**STAFF REPORT**  
(Preliminary Plat)

**CASE NUMBER:** SUB 2000-76 -- SOUTHWIND ESTATES ADDITION

**STAFF REPORT**  
(Final Plat, Preliminary Plat Approved 9/28/00)

STAFF REPORT

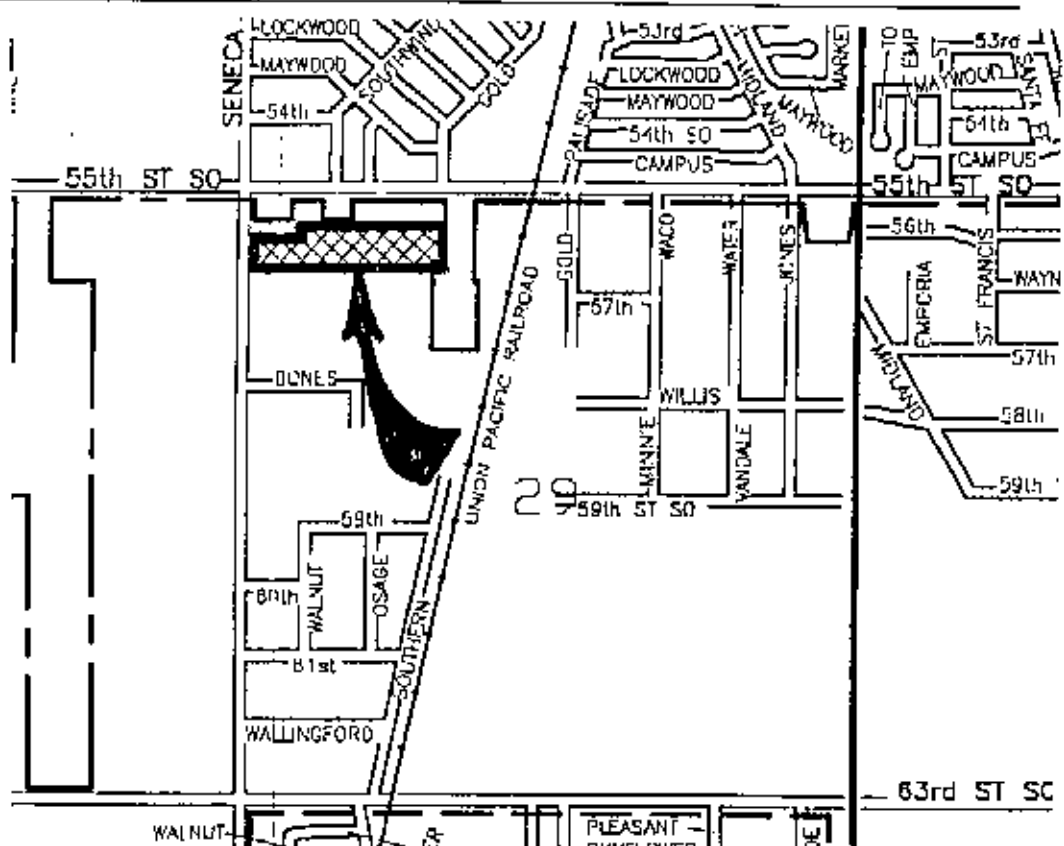
- C. Southwind Street has been platted as a 32-ft narrow local residential street. The Subdivision regulations state that streets of this type are not intended for street patterns subjected to through traffic or traffic generated by land uses not directly fronting onto the narrow street. Therefore Southwind Street should be increased to a minimum of 64-ft right-of-way.

- E. Traffic Engineering needs to comment on the access controls. The plat proposes two access openings along Seneca for Lot 1. The final plat shall reference the access controls in the plat's text.

- F. A turnaround shall be platted at the terminus of Southwind Street.
- G. City Fire Department needs to comment on the proposed street names.
- H. If platted, the building setback along Seneca may be a minimum of 20 feet to conform with the LC District zoning standards.

- I. The tie points shall be revised to reference "T29S".
- J. The applicant is reminded that a platting binder is required with the final plat. Approval of this plat will be subject to submittal of this binder and any relevant conditions found by such a review.

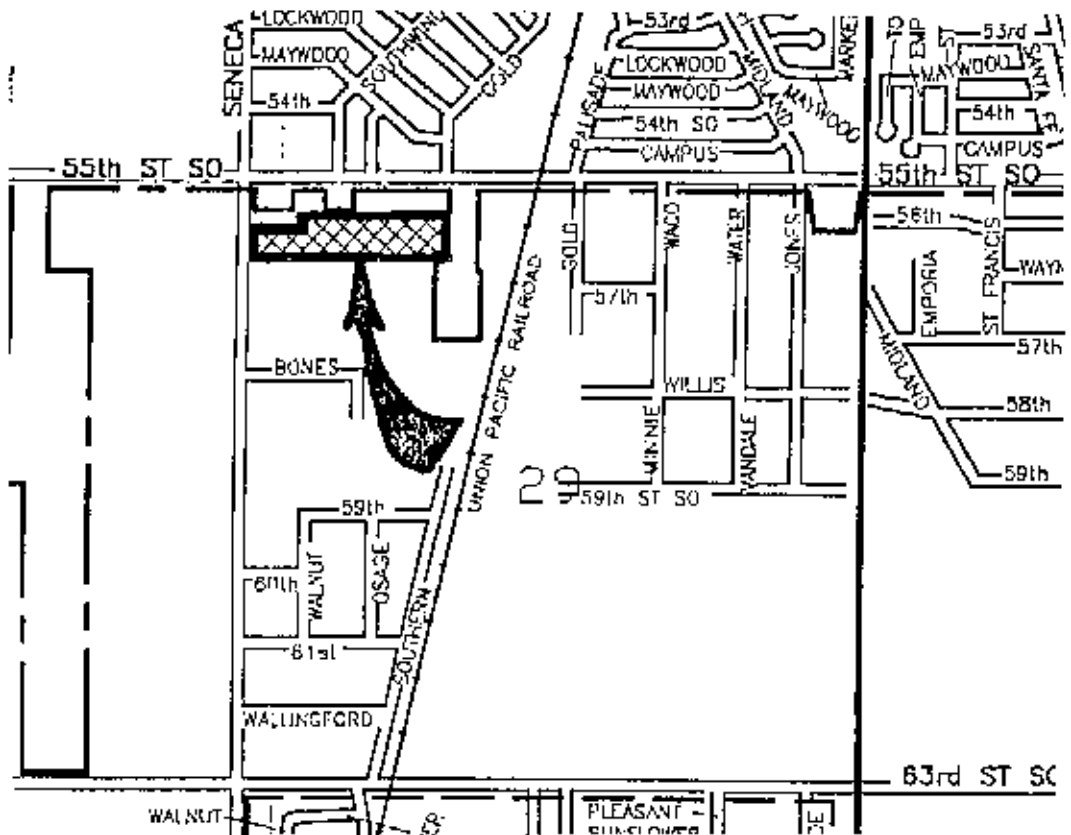
- D. Southwind Street has been platted as a 32-ft narrow local residential street. The Subdivision regulations state that streets of this type are not intended for street patterns subjected to through traffic or traffic generated by land uses not directly fronting onto the narrow street. Therefore MAPD and Traffic Engineering recommend that Southwind Street be increased to a minimum of 64-ft right-of-way. The Subdivision Committee has approved the 32-ft street right-of-way.

- E. The applicant shall provide a guarantee for the installation of the proposed streets.
- F. Traffic Engineering needs to comment on the access controls. The plat proposes two access openings along Seneca for Lot 1. The final plat shall reference the access controls in the platlor's text. Traffic Engineering recommended one opening along Seneca; however the Subdivision Committee approved two openings.

- I. The applicant has platted 15-ft and 20-ft building setbacks for Lots 8 and 9 which represents an adjustment of the Zoning Code standard of 25 feet for the SF-6, Single-Family District. The Subdivision Regulations permit the setback provisions to be modified by the plat upon the approval of the Planning Commission.

- T. The representatives from the utility companies should be prepared to comment on the need for any additional utility easements to be platted on this property. KGE has requested additional easements. Southwestern Bell has requested that the 15-ft street drainage and utility easement be increased to 20 feet.

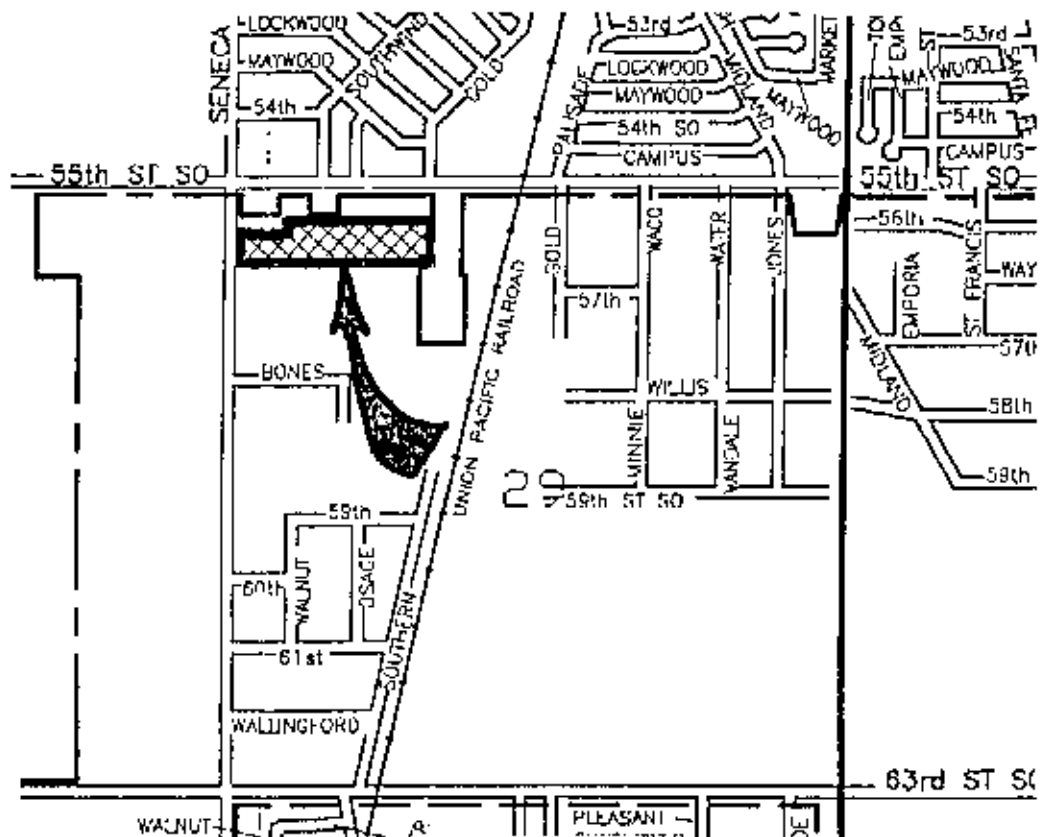
- C. City Engineering has required a 15-foot drainage and utility easement along the south line of Lot 2. A contingent easement may be platted through the existing structure. An off-site 15-foot drainage and utility easement is also required along the south right-of-way line of Tumbleweed Street.

- E. Southwind Street has been platted as a 32-foot narrow local residential street. The Subdivision regulations state that streets of this type are not intended for street patterns subjected to through traffic or traffic generated by land uses not directly fronting onto the narrow street. Therefore, MAPD and Traffic Engineering recommend that Southwind Street be increased to a minimum of 64-foot right-of-way. The Subdivision Committee has approved the 32-foot street right-of-way.

- H. Since this plat proposes the platting of narrow street right-of-way with adjacent "15-foot street drainage and utility easements", a restrictive covenant shall be submitted which calls out restrictions for lot-owner use of these easements. Retaining walls and change of grade shall be prohibited within these easements, as well as, fences, earth berms and mass plantings.

- I. Traffic Engineering needs to comment on the access controls. The plat proposes two access openings along Seneca for Lot 1. The final plat shall reference the access controls in the platting's text. Traffic Engineering recommended one opening along Seneca; however, the Subdivision Committee approved two openings due to existing openings approved with previous plats.

- M. The applicant has platted 15-foot and 20-foot building setbacks for Lots 8 and 9, which represents an adjustment of the Zoning Code standard of 25 feet for the SF-6, Single-Family District. The Subdivision Regulations permit the setback provisions to be modified by the plat upon the approval of the Planning Commission.

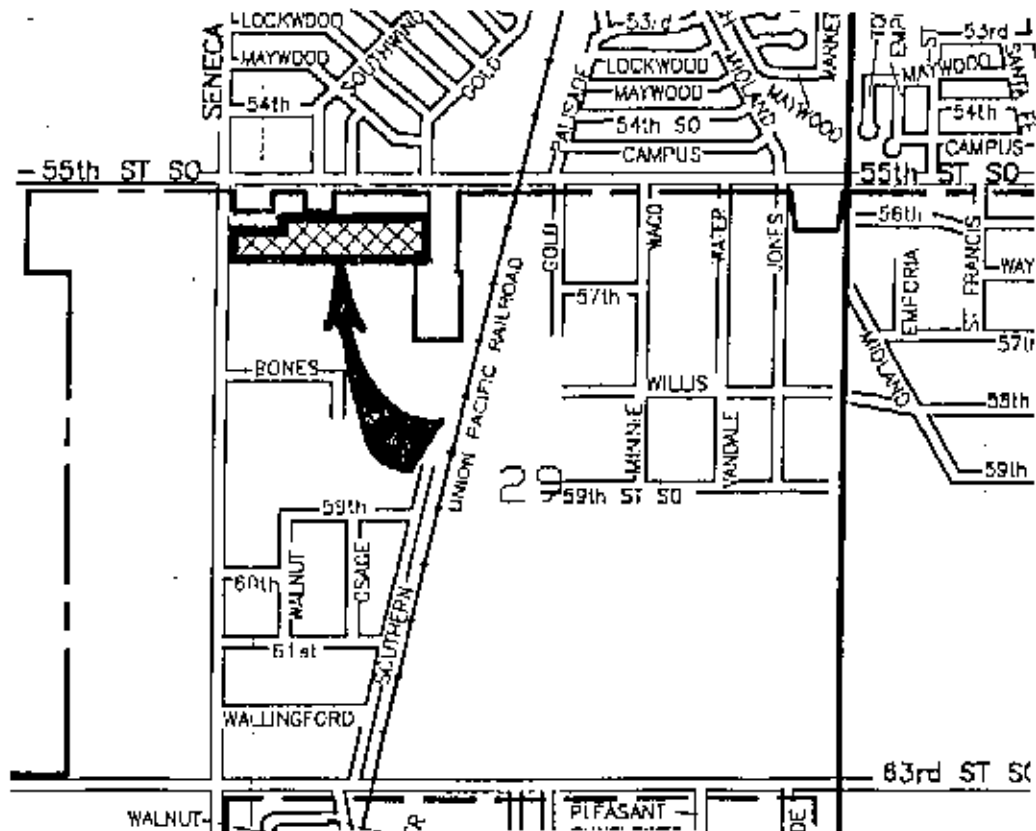
- D. Southwind Street has been platted as a 32-ft narrow local residential street. The Subdivision regulations state that streets of this type are not intended for street patterns subjected to through traffic. Therefore MAPD and Traffic Engineering recommend that Southwind Street be increased to a minimum of 58-ft right-of-way.

- E. A north-south street right-of-way shall be dedicated at approximately 1,000 feet east of Seneca in alignment with Osage to the south to enable future connections with adjoining properties.

- I. Since Lots 3 and 4 are zoned LC, Limited Commercial, a 70-ft commercial street is required with all access to commercial lots from this street or in the alternative, a restrictive covenant shall be provided limiting the uses of Lots 3 and 4 to those permitted under the SF-5, Single-Family Residential District.

- J. Traffic Engineering needs to comment on the access controls. The plat proposes two access openings along Seneca. The final plat shall reference the access controls in the platlor's text. Traffic Engineering has permitted one opening for both Lots 1 and 2; however, upon the conversion of Lot 2 from residential to a commercial use, a joint driveway located on the common property line will be required, with the closure of both driveways.

- L. Approval of this plat will require a waiver of the lot depth to width ratio of the Subdivision Regulations for Lots 1-8, Block 1, and for Lots 6-16, Block 2. The Subdivision Regulations state that the maximum depth of all residential lots shall not exceed 2.5 times the width.

- M. The paving guarantee shall include the installation of a temporary turnaround at the terminus of Tumbleweed at the plat's east line. On the final plat, the platator's text should indicate that the vacation of the temporary turnaround area will be effective upon the extension of the street eastward.
